Service Bulletin N° 93

DATE: January 27, 1997

SUBJ: F.Y.I We have identified a problem in a small quantity of I/O Power Driver Boards (less than 50) that may have been installed into Space Jam Games. (Sorry, but we are unable to supply a serial number breakdown for verification.)

Fig. 1 Incorrect

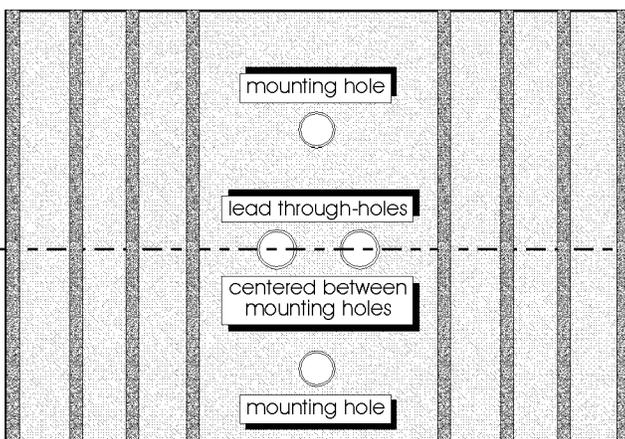
Explanation: The heat sink for the LM338K +5 Volt Regulator (TO-3 Transistor Package) was incorrectly manufactured (the through-holes in the *Heat Sink* for the two leads of the LM338K were not located correctly and may short the leads against the *Heat Sink* or the *Heat Sink to the Solder Pads* (See Fig. 1).

When this occurs, the unregulated input DC voltage (approx. 8 ~ 9v DC) can be directly shorted to the *Heat Sink* and thus to the case of the regulator. Since the regulator case is also the regulated voltage output connection, this means that 8 or 9v DC can appear on the +5 Volt Power Bus of the game. This will cause an assortment of strange symptoms ranging from random game malfunction (chattering flippers, bad Dot Display, bad sound) to failure of other game PCBs due to overvoltage conditions. **The best way to verify this condition in your game is to simply meter the +5 Volt supply. If you see any reading higher than 5.5v DC, the heat sink is the prime suspect.**

The **next step in verification** is a little more complicated: the regulator must be de-soldered from the I/O Board and the through-hole location for the transistor leads on the *Heat Sink* should be inspected. If the two holes are **CENTERED** between the two mounting holes (on the ends) instead of *offset* (closer to one of the mounting holes, matching the leads on the TO-3 Case), the *Heat Sink* is **BAD** (See Fig. 1).
